SWITCH PLATE ASSEMBLY ALONG WITH USB & 3-PIN MOBILE CHARGING SOCKET
FOR LHB EOG NON-AC COACHES FOR AMRIT BHARAT RAKE

CORR-1 FOR SWITCH PLATE ASSEMBLY ALONG WITH USB & 3-PIN MOBILE CHARGING SOCKET
FOR LHB EOG NON-AC COACHES FOR AMRIT BHARAT RAKE

This document is prepared to EDML-243, Rev-Nil for removal of spare/extra 1.0 Amp. Glass fuses (with holders) in Switch plate assemblies with Type - A & C USB type Mobile Charging Socket & 3-pin Socket 6A, 250V AC and revision of switch plate assemblies for LHB EOG Non AC Pantry Coach (Amrit Bharat Rake).

➤ **Table -4 FOR LHB EOG NON-AC PANTRY CAR.**

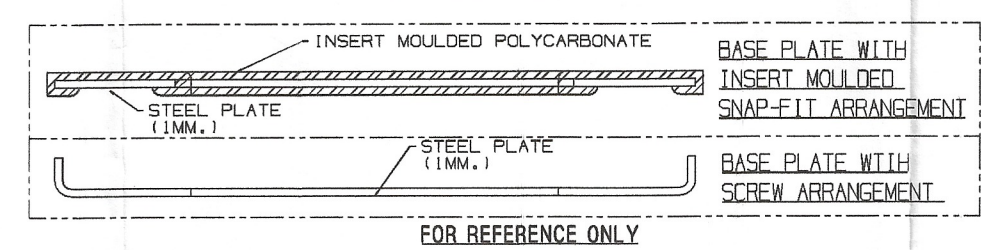
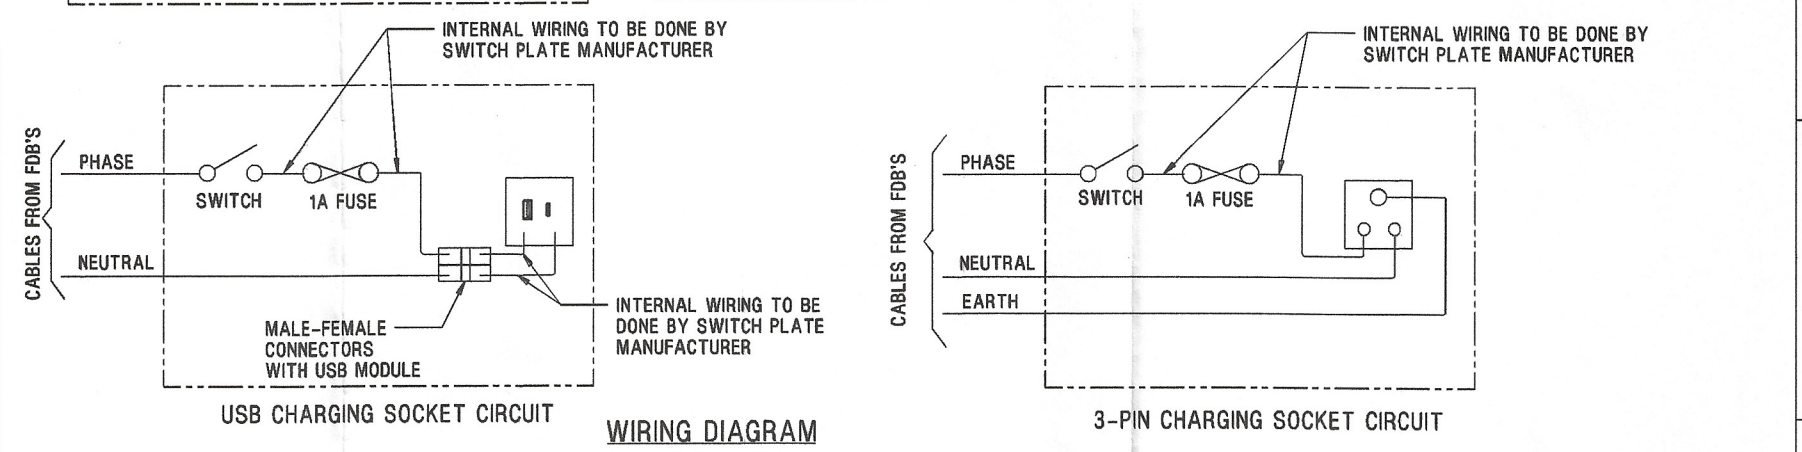
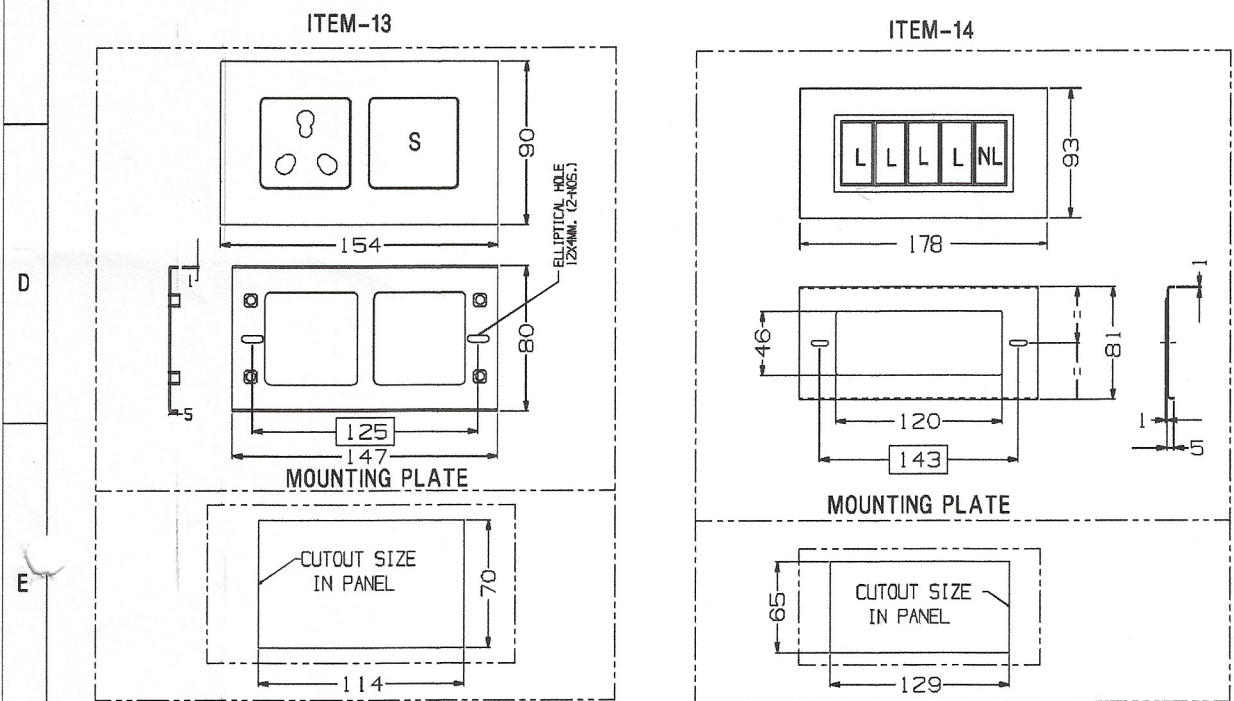
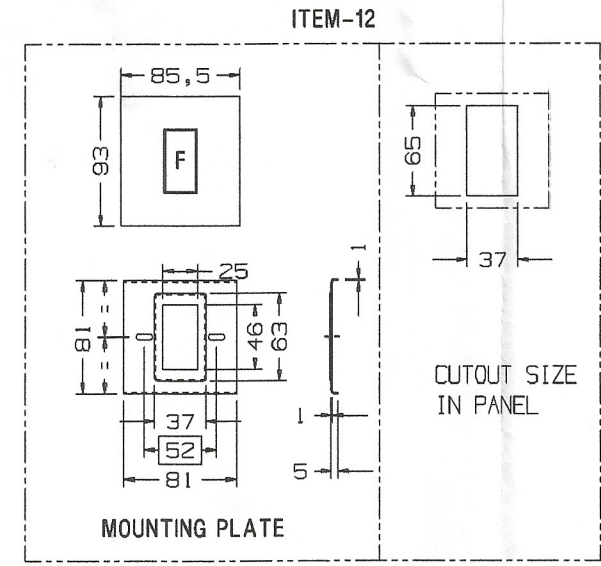
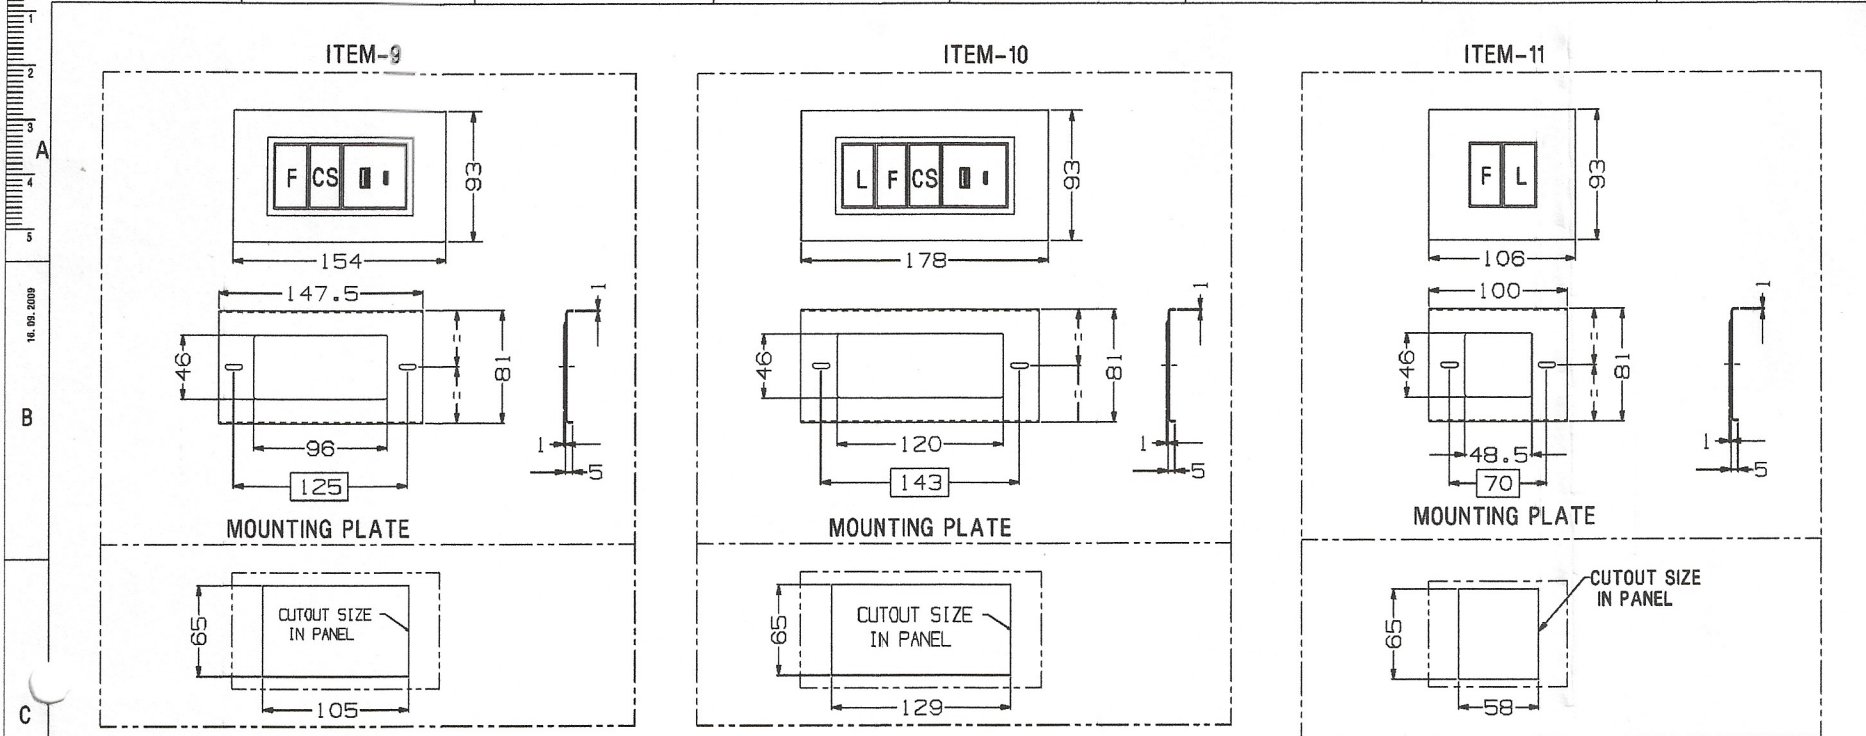
1. **Spare 1.0 Amp** Glass fuse (with fuse holders) in Switch plate assemblies each with Type - A & C USB type Mobile Charging Socket & 3-pin Socket 6A, 250V AC **stands deleted**. i.e. Only **01 No.** 1.0 Amp Glass fuses of M/s Ferraz Shawmut/ Copper Bussmann/ equivalent* (with fuse holders) is to be provided each for Type - A & C USB type Mobile Charging Socket & 3-pin Socket 6A, 250V AC. This is applicable for Table-1,2 and 3.
2. **Drg. No. CC74261, Alt-Nil** shall be read as **Drg. No. CC74261, Alt-'a'**.
3. **Table-4 updated in reference to revised ICF Drawing No. LWCB/PP-7-4-001, Alt-'a'** shall be read as under:-

SN	Description	Qty.	Marking on switches	Ref. Drg. No.	Remarks (Location)
1	Switch plate assembly complete with polycarbonate cover frame and powder coated steel plate with 04 nos. ON-OFF switches, 01 no. Type -A & C USB mobile charging socket & 01 no. 3-pin socket 6A,250V AC with 02 nos. 1.0 Amp Glass fuses of M/s Ferraz Shawmut/ Copper Bussmann/ equivalent* (with fuse holders)	01 Set (01 set comprising 03 switch plates)	CS, F,F,CS	Drg. No. CC74261 Alt-'a', Item-2	Cabin Area
2	Switch plate assembly complete with polycarbonate cover frame and powder coated steel plate with 04 nos. ON-OFF switches, 01 no. Type -A & C USB mobile charging socket & 01 no. 3-pin socket 6A,250V AC with 02 nos. 1.0 Amp Glass fuses of M/s Ferraz Shawmut/ Copper Bussmann/ equivalent* (with fuse holders)	01 Set (01 set comprising 03 switch plates)	CS,L,F, CS	Drg. No. CC74261 Alt-'a', Item-2	Cabin Area (Marking Different)

3	Switch plate assembly complete with polycarbonate cover frame and powder coated steel plate with 01 no. ON-OFF switch and 01 no. Type -A & C USB mobile charging socket with 01 no. 1.0 Amp Glass fuse of M/s Ferraz Shawmut/ Copper Bussmann/ equivalent* (with fuse holders)	01 Set (01 set comprising 06 switch plates)	CS	Drg. No. CC74261 Alt-'a', Item-4	Cabin Area (Lower Berth)

4	Switch plate assembly complete with polycarbonate cover frame and powder coated steel plate with 02 nos. ON-OFF switches.	01 Set (01 set comprising 01 switch plates)	L,F	Drg. No. CC74261 Alt-'a', Item-11	Service Counter Area
5	Switch plate assembly complete with polycarbonate cover frame and powder coated steel plate with 02 nos. ON-OFF switches.	01 Set (01 set comprising 03 switch plates)	L,NL	Drg. No. CC74261 Alt-'a', Item-11	Corridor Area (Marking Different)
6	Switch plate assembly complete with polycarbonate cover frame and powder coated steel plate with 02 nos. ON-OFF switches.	01 Set (01 set comprising 01 switch plates)	L,L	Drg. No. CC74261 Alt-'a', Item-11	Corridor Area (Marking Different)
7	Switch plate assembly complete with polycarbonate cover frame and powder coated steel plate with 05 nos. ON-OFF switches.	01 Set (01 set comprising 01 switch plate)	L,L,L,L,NL	Drg. No. CC74261 Alt-'a', Item-14	Corridor Area

8	Switch plate assembly complete with polycarbonate cover frame and powder coated steel plate with 05 nos. ON-OFF switches.	01 Set (01 set comprising 02 switch plate)	F,F,F,F,F	Drg. No. CC74261 Alt-'a', Item-14	Corridor Area (Marking Different)
9	Switch plate assembly complete with polycarbonate cover frame and powder coated steel plate with 05 nos. ON-OFF switches.	01 Set (01 set comprising 01 switch plate)	L,L,L,NL, SP	Drg. No. CC74261 Alt-'a', Item-14	Corridor Area (Marking Different)
10	Switch plate assembly complete with polycarbonate cover frame and powder coated steel plate with 01 no. ON-OFF switch and 01 no. 3-pin socket 6A,250V AC with 01 no. 1.0 Amp Glass fuse of M/s Ferraz Shawmut/ Copper Bussmann/equivalent* (with fuse holders) (for 03-Nos water purifier)	01 Set (01 set comprising 03 switch plates)	S	Drg. No. CC74261 Alt-'a', Item-6	Pantry Equipments (Marking Different)
11	Switch plate assembly complete with polycarbonate cover frame and powder coated steel plate with 01 no. 16A, 250V AC ON-OFF switch and 01 no. 6/16,250V AC Socket. (for 02-Nos. Refrigerator, 01 No. Deep Freezer & 02-Nos. Hot/Cold under storage)	01 Set (01 set comprising 05 switch plates)	S	Drg. No. CC74261 Alt-'a', Item-13	Pantry Equipments
